REPORT NO. 212003/1

**MYRA FALLS OLD TAILINGS DISPOSAL FACILITY
2013 DAM SAFETY REVIEW**

October 2013

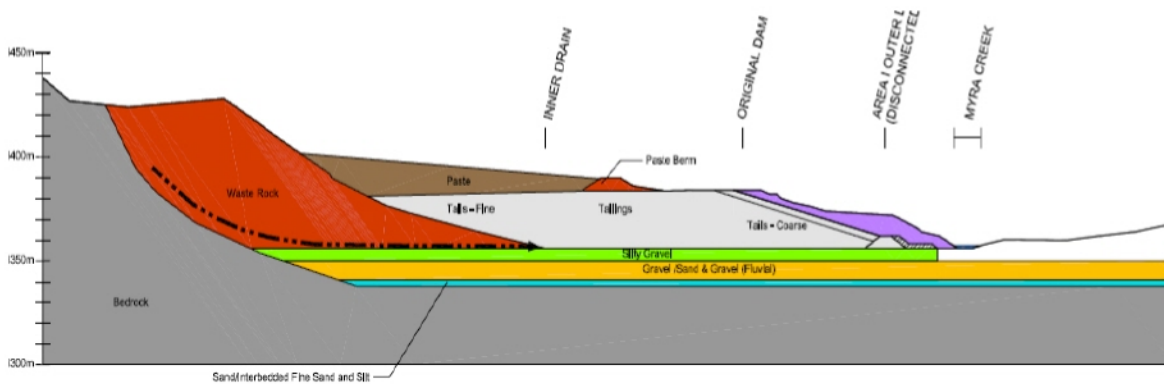
Waste rock dumps 1 and 6 to the north of the TDF rise at their natural angle of repose above the adjacent tailings surface. Note these rock dumps also underlie the tailings as shown in the Figure 3 below.

The writers of this report were informed that in accordance with Hoffman (2013) the stability and cover for these dumps are being reevaluated and action will be taken in accordance with plans for the closure of the TDF.

While we are of the opinion that these dumps do not currently constitute a dam safety issue, we concur that as part of closure their stability and covering should be addressed.

Figure 13. Cross section of the seismic berm (from AMEC, 2011.) Note the seismic berm is to the right of the section and is constructed over the previous outer face of the TDF.

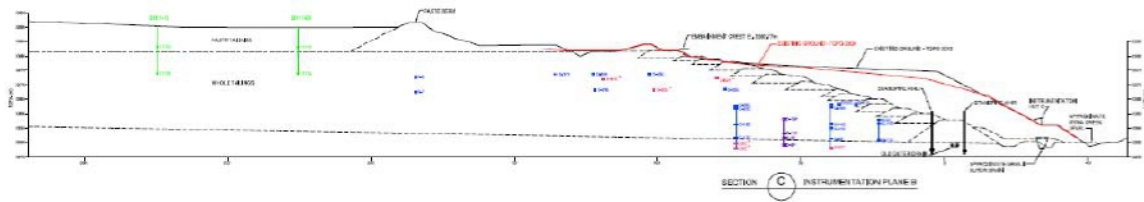
The seismic berm was constructed on the south side of the TDF in order to provide for stability of the TDF in the event of large earthquakes. The analysis of the stability of the berm and its design are documented in Klohn Crippen Consultants Ltd. (1999a) and (2004a), and AMEC (2011). The latter presentation notes factors of safety for the TDF for various earthquakes that are consistent with industry standards. The presentation also notes “Even with adequate factor of safety, some liquefaction-related deformation is anticipated in the APA and TDF following the MCE.” The calculated deformation under the most extreme seismic loading by the Maximum Credible Earthquake, is that “the berm will horizontally translate about 3 m to 4 m into Myra Creek and the tailings surface at the berm will vertically drop 1.5 m to 2.0 m.” This deformation has been calculated using standard procedures and is consistent with similar calculated deformation for other facilities in high seismic areas.

In terms of Hoffman (2013) “Updated slope stability analyses shall be undertaken to complete the detailed closure design for the TDF.” In the opinion of the writers of this report, such a course is necessary and appropriate.

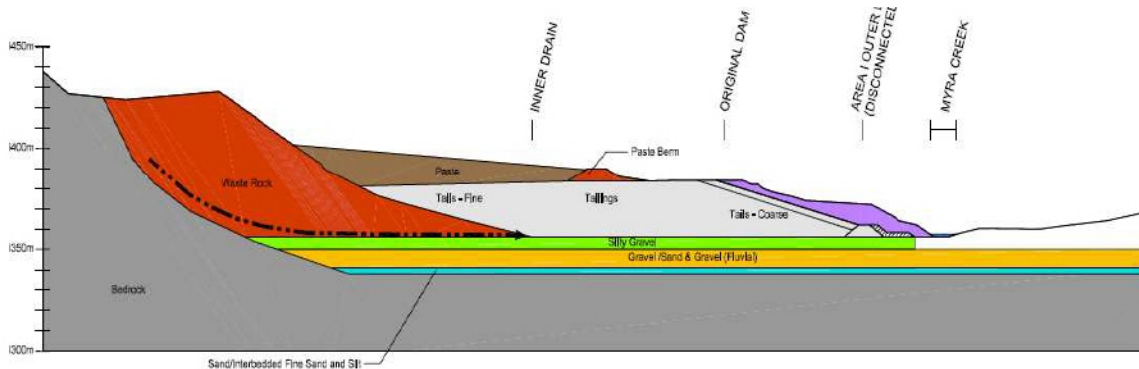
Waste rock dumps 1 and 6 to the north of the TDF rise at their natural angle of repose above the adjacent tailings surface. Note these rock dumps also underlie the tailings as shown in the Figure 3 below.

The writers of this report were informed that in accordance with Hoffman (2013) the stability and cover for these dumps are being reevaluated and action will be taken in accordance with plans for the closure of the TDF.

While we are of the opinion that these dumps do not currently constitute a dam safety issue, we concur that as part of closure their stability and covering should be addressed.

Figure 13. Cross section of the seismic berm (from AMEC, 2011.) Note the seismic berm is to the right of the section and is constructed over the previous outer face of the TDF.

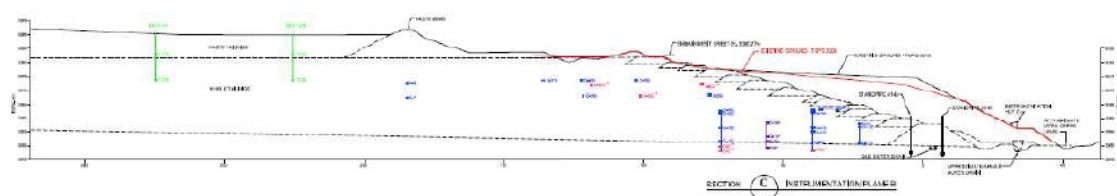
- ☐ Desktop study of existing engineering design reports by others, including limit-equilibrium and finite-element stability modeling by Klohn Crippen;
- ☐ Supplementary/confirmatory limit-equilibrium stability analyses carried out by AMEC;
- ☐ Documentation of construction activities by others;
- ☐ Construction observations performed by AMEC; and,
- ☐ Review of the final survey data provided by McElhanney.

In our opinion, these conclusions as based on the documents reviewed, are reasonable and acceptable.

Figure 18. Static stability analyses for the Lynx TDF. Note the failure surface through the tailings and beneath the rockfill embankment passes through a till of high strength. This figure is the basis of a conclusion that the embankment has an adequate static factor of safety.

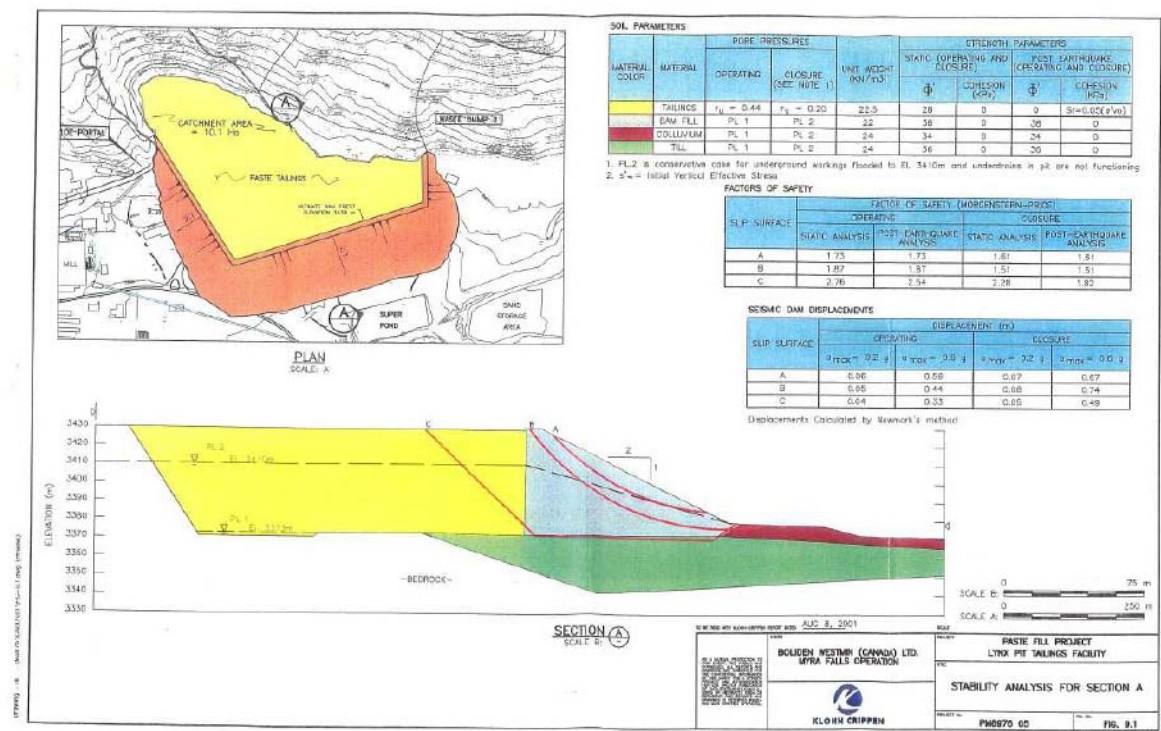
AMEC (2008b) describes slope stability analyses of the Lynx TDF. As noted in Figure 18, failure surfaces through the tailings and beneath the embankment assume that the foundation materials are a high-strength, cohesionless till.
